NEPAL ELECTRICITY AUTHORITY
PROJECT MANAGEMENT DIRECTORATE
POWER TRANSMISSION AND DISTRIBUTION SYSTEM STRENGTHENING PROJECT
LALITPUR-BHAKTAPUR DISTRIBUTION SYSTEM REINFORCEMENT PROJECT

PMD/PTDSSP/LBDSRP-076/77-01: Design, Supply, Installation and Commissioning of Underground Distribution Network under Lagankhel, Pulchowk, Bhaktapur and Thimi Distribution Center including Reinforcement and Automation.

BIDDER'S CLARIFICATION NO. - I

FIG. 1-1 : CONCEPTUAL CONFIGURATION OF DC POWER SUPPLY (DCPS) SYSTEM (For Field Sites Locations)

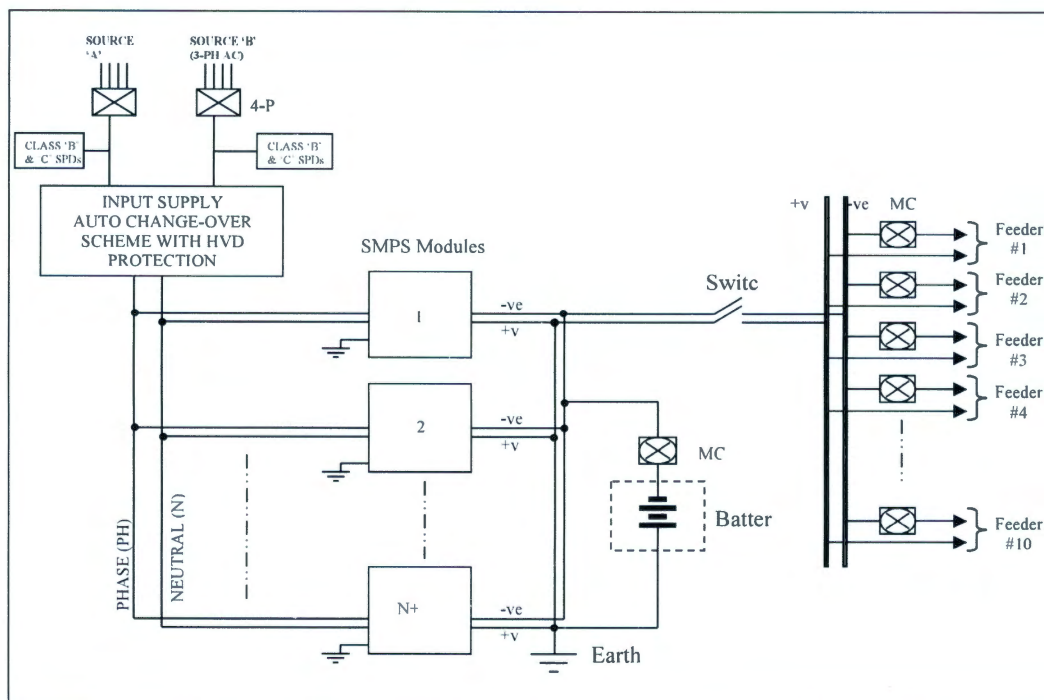
The DC Power supply system shall have a single DCPS system as per conceptual configuration diagram given in Fig.1-1, shall be supplied.

TENTATIVE UG_LINE
 Minbhawansubstation
 Patansubstation
 Tekusubstation
 thapathaliswitchingstation
 World Street Map

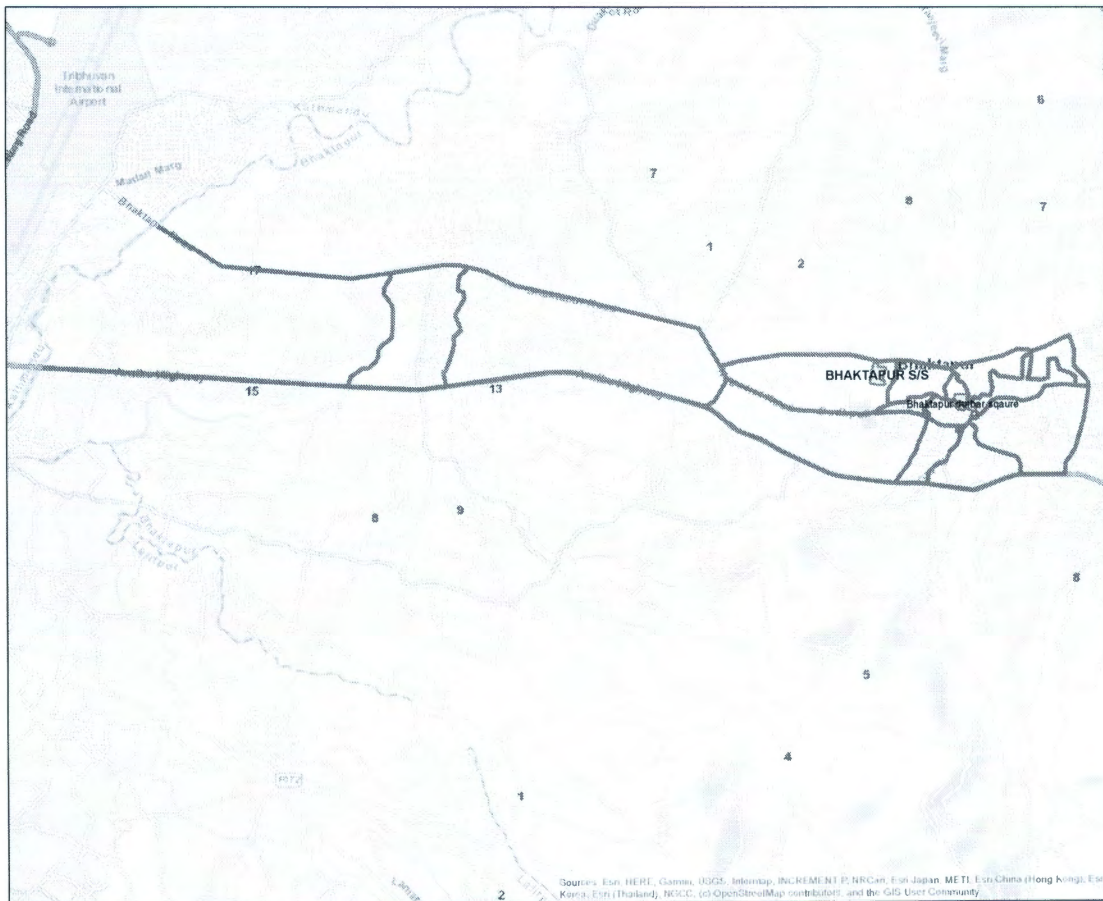
S.No.	Section	Reference to Tender Clause		Description	Bidder's Queries	Employer's Response
53	6	Volume-II/ Section 6.1 – Project Specific Requirement	Page No. 23-25 No. 15 Clause	Service Level Agreement (SLA)	As per Volume – I /General Condition of Contract Page No. 147, Clause No. 27.2 Defect Liability Period is 540 days from the date of Completion of the Facilities (or any part thereof) or 1 year from the date of Operational Acceptance of the Facilities and Volume – I /Special Condition of Contract Page No. 188, Clause No. 27 Defect Liability Period - The critical components covered under the extended defect liability are XLPE cables, Distribution Transformers, Communication equipment, ABC Cables and RMU units and the period shall be 730 days. We are requesting you to kindly delete the clause SLA.	SLA will be applicable along with Defect Liability Period (DLP) and Extended DLP.
54		Vol.-II, PSR, Appendix-III			Please provide survey map (tentative area of working-UGC)	The tentative map of the UG cable route is attached in the appendix-E
